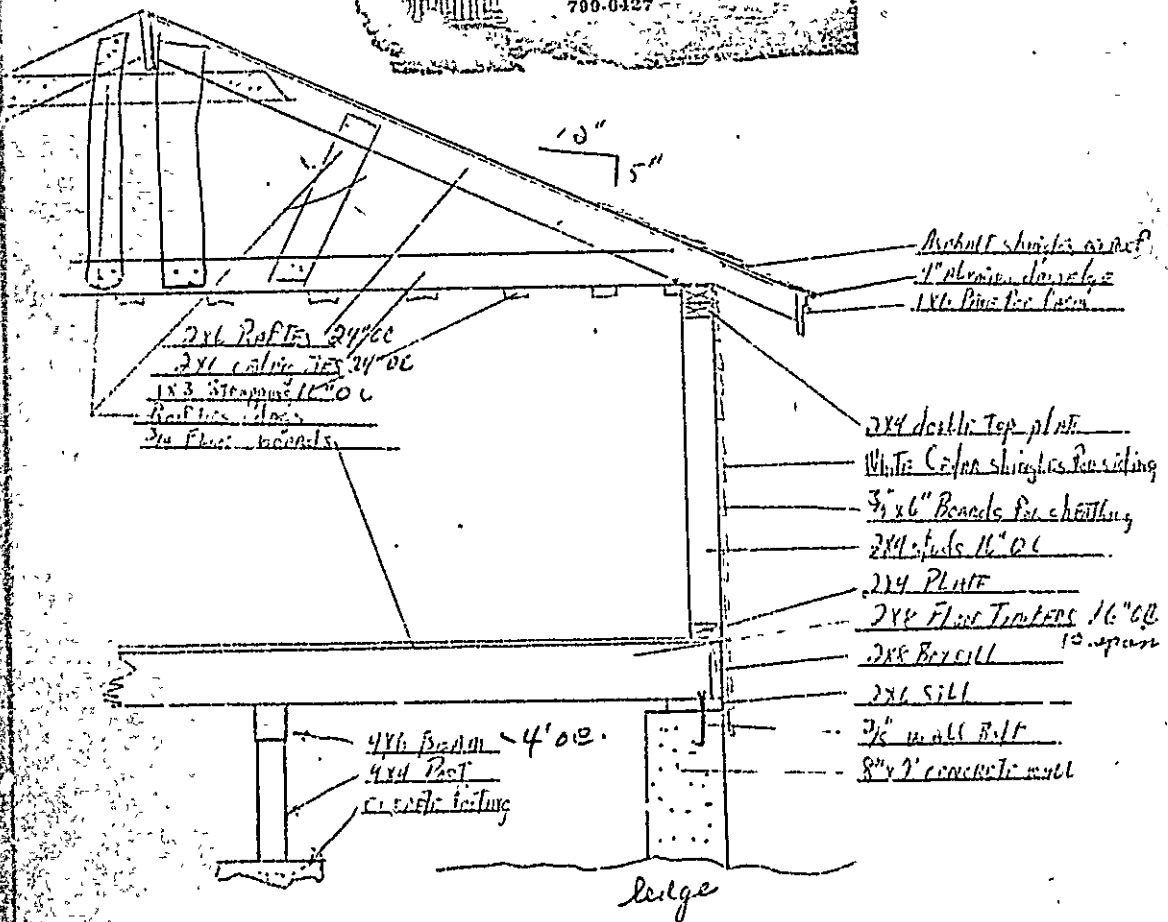
The cross section shows a 4x6 beam with a 4x4 post under it. What will be the distances between the upright posts?

What size headers will be used over the picture window?

Who supplies Trusses
 What span is 4x6 on
 FTG under posts 4' below peak }
 Headers over picture windows }

4 ft

*4" x 6" - 3 span
stud
pockets*

— PLAN of GARAGE ADDITION —

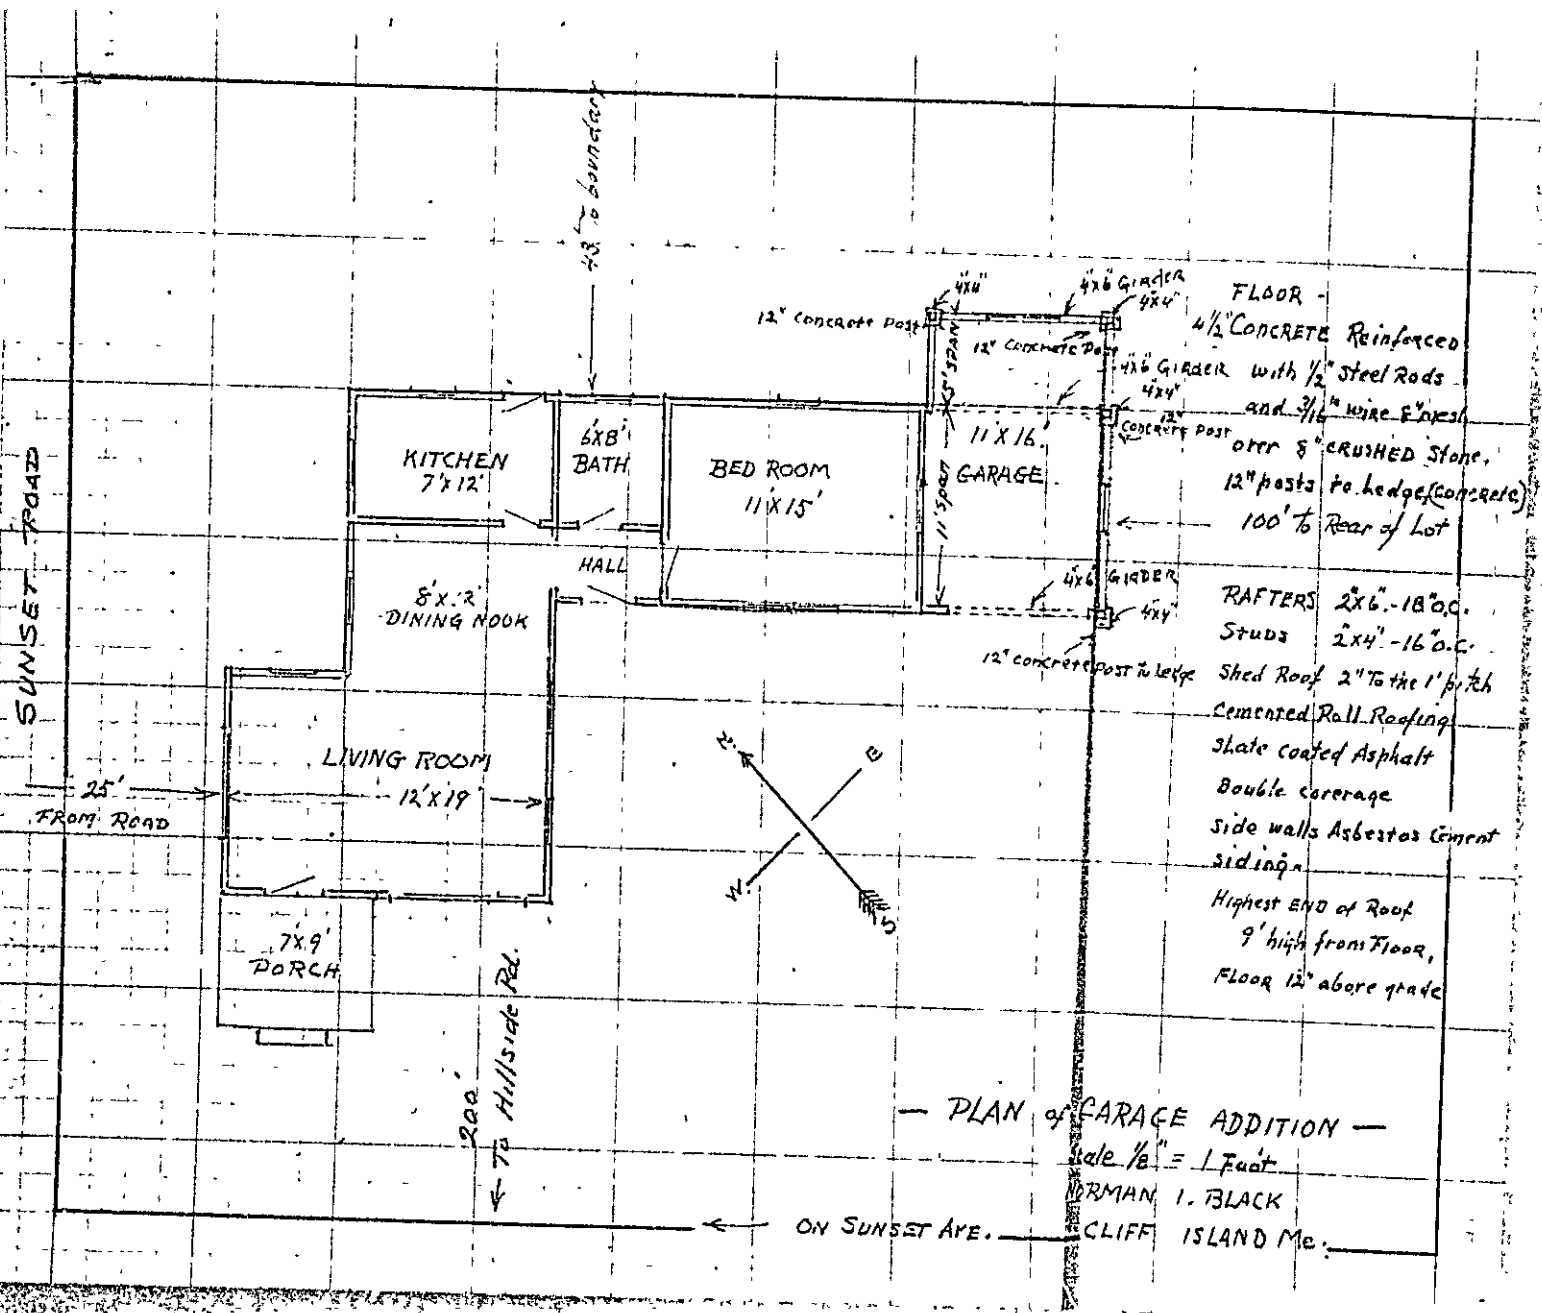
In the wall between the house and garage a plain glass window in a wood frame has been cut in. The specifications on your plan, filed at this office for this addition upon which the permit was issued, specified the proper separation but did not mention this window.

Sect. 202b2 of the Building Code says in part "12/15/41) Sheets of combined asbestos and cement not less than three-eighths of an inch in thickness with joints filled with cement mortar, or at least one-half inch of plaster on perforated gypsum lath or on metal lath shall be provided on the garage side of partitions and ceilings between a dwelling house part and accessory garage part of a building;"

2. It appears that you have a 4x6 with the 6 inches set upright across the proposed garage in line with the rear wall of the existing shop, that the 2x6 roof joists are 18 inches from center to center and run the depth of the garage, supported on the front wall over the large door, supported on the rear wall, and in between on the 4x6 running across the garage so that the spans of the 2x6 roof joists are now 11 feet and 5 feet. The 2x6s on the 11 foot span are not strong enough. To make up for this deficiency another 4x6 with 6-inch dimension upright is to be run across under the roof about 4 feet toward the front of the garage from the existing 4x6 under the roof, thus to make the front span of the 2x6s about 7 feet.

3. The 4x6 beams under the roof joists are not strong enough for the 11 foot span on which they would be; so, you are to introduce 4x4 knee braces under each end of each 4x6. These knee braces are to support the 4x6s at a point 2 feet from each end and are to be supported on the posts which support the 4x6s at 2 feet from the lower edge of the 4x6. The lower end of the 4x4 braces may be let into the post, but the outer end of the braces are to be cut at the "toe" so that they will butt against a 2x4 "kick" strip spiked to the lower edge of the 4x6s.

4. There is to be a foundation pier of concrete beneath each post and these piers are to be no less than 8 inches square or in diameter at the surface of the ground and no less than 10 inches square or in diameter at the bottom of the pier. Each pier is to extend 4 feet below the surface of the ground or to ledge, if solid ledge is encountered at a less depth. I am uncertain as to how you have arranged these piers and the concrete floor slab of the garage and you may get frost action beneath the floor slab and defeat the purpose of putting the pier 4 feet below the grade or to ledge. I have the impression that you have the concrete slab all built

and that you have run it right out over the piers. If that is the case, I shall be somewhat concerned that you do not have frost action take place. If you have not already done it, the best way is to cut the slab back of the piers and support the wooden frame of the building directly on the piers using metal dowels to fasten the woodwork to the concrete piers. That would mean that between the piers would run no less than 4x6 solid sill with the 6-inch dimension upright and this would not be supported upon the floor slab, but would be independently supported upon the piers. On the sills, of course, you would erect the no less than 2x4 studs to make the enclosing walls, which should be no more than 24 inches from center to center, and the corner posts would have to be at least 4x4 or doubled 2x4 with doubled 2x4 plates at the top of the walls.

5. Of course, you are aware that a larger header will be needed over the large doors and that doubled 2x4 headers will be required over the windows with short studs under each end of each header.
6. It is not known what you intend to use for weatherproof covering on the outside of the wall. This is required to be permanently weather resistant and any material which can be rolled up will not be acceptable for this purpose.

It is necessary that this window be removed to correct this condition before September 3rd, 1953, and notify this office of readiness for another inspection.
